# Release note

Product: TR311HWV2/TR313V2/TR323NV2/TR333V2

4. Power schedule (Webpage/ System/ Power schedule)

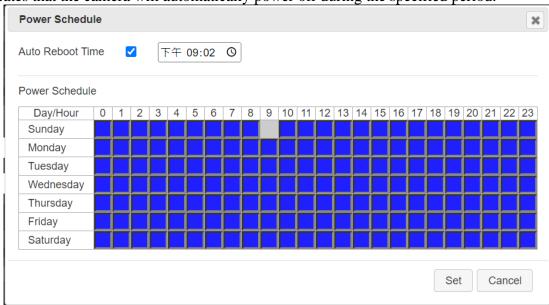
Auto reboot time, able to set a specific time for the camera to automatically reboot on a daily basis.

Powe Power Schedule: Able set a specific time for the camera to power off by simply clicking on the designated blue cell. When you click the cell and its color change from blue to grey, it indicates that the camera will automatically power off during the specified period.

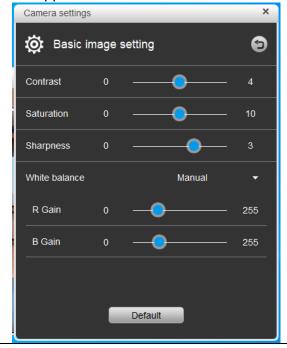
- 5. SW\_Captureshare is able to support the Tracking camera for follows configuration:
  - 1). FW upgrade
  - 2). Tracking setting (Presenter/Zone/Hybrid)
  - 3). R/B gain
  - 4). Visible camera information, including Model name, IP address, Mac address, serial number, and FW version.

From SW\_Captureshare Version1.3.2077.0 to support those functions.

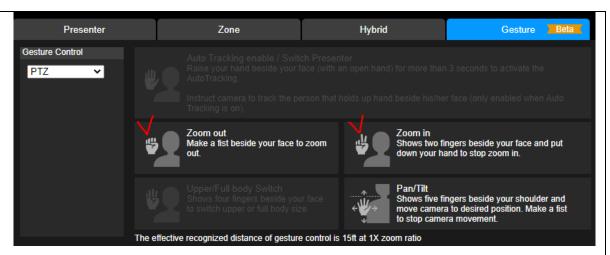
21. Optimize zoom-in gesture functions, use "TWO" to do the zoom-in function. See the following description.

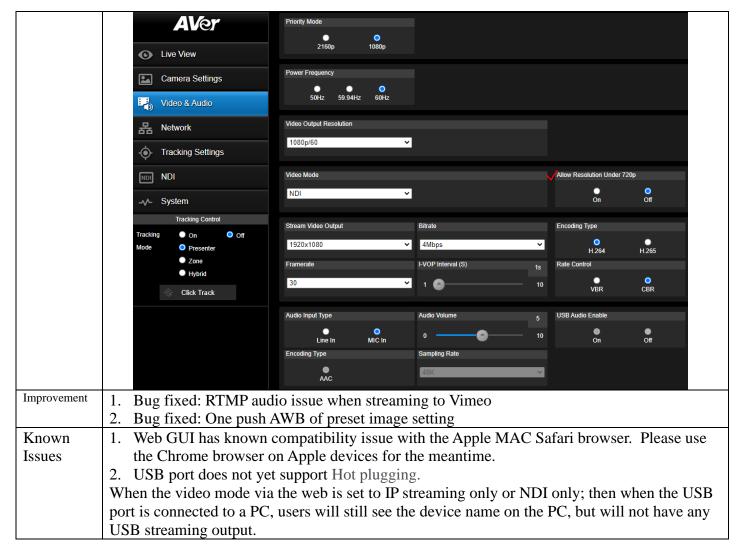
6. Allow Resolution Under 720p: Select On to allow transferring lower resolution video streaming when working with some video conference software such as Teams. It's recommended to select Off if you want to keep better image quality during video call.
